ABSOLUTE SOLUTIONS INC.

UNIVERSAL ACCESS FUND RTP SITE VALIDATION & ACCEPTANCE REPORT

8 February 2021

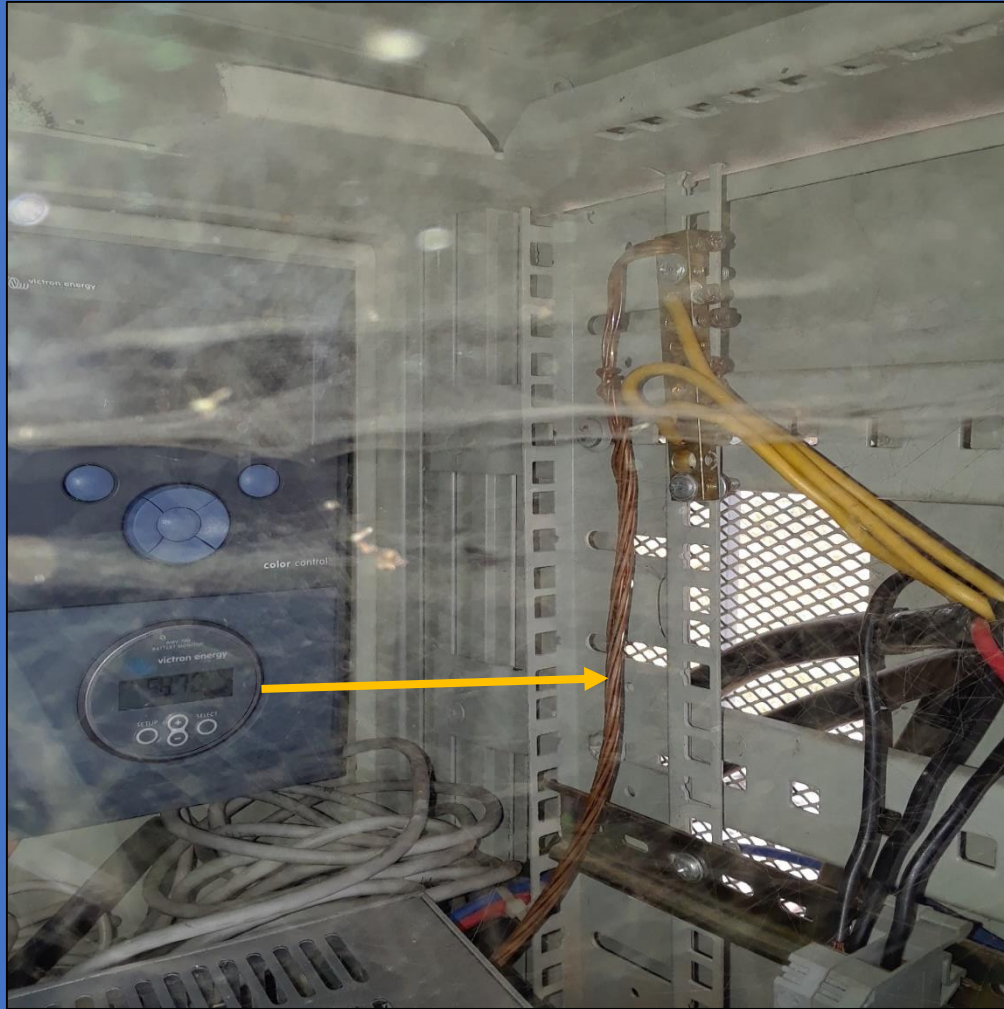
Grounding cable in the cabinet is bare.

Grounding cable for the fence is 16mm², not the standard for outdoor.

- Enable or check 2G EDGE parameter settings for internet connectivity.
- Check parameter settings to reduce call setup time to <15 sec.
- Check parameter settings to improve voice quality score.
- The site needs bi-annual maintenance.
- All metal tie wraps must to be replaced with rubber tie wraps, to meet telecommunications installation standard.
- All four legs of the tower need grounding.
- Bare grounding cables on the tower and in the cabinet must be changed to 72mm² coated grounding cable.
- Waveguide and jumper cables on RRUs need proper putty and tape for protection.
- Fabricated arm on the tower needs to be replace soon, else it will break, and the antenna will fall.
- Free hanging cables on the tower need cable holder.
- Grounding cables on fence should be 25mm² or 35mm² coated.
- Grounding test needs to be conducted for grounding system at the site.
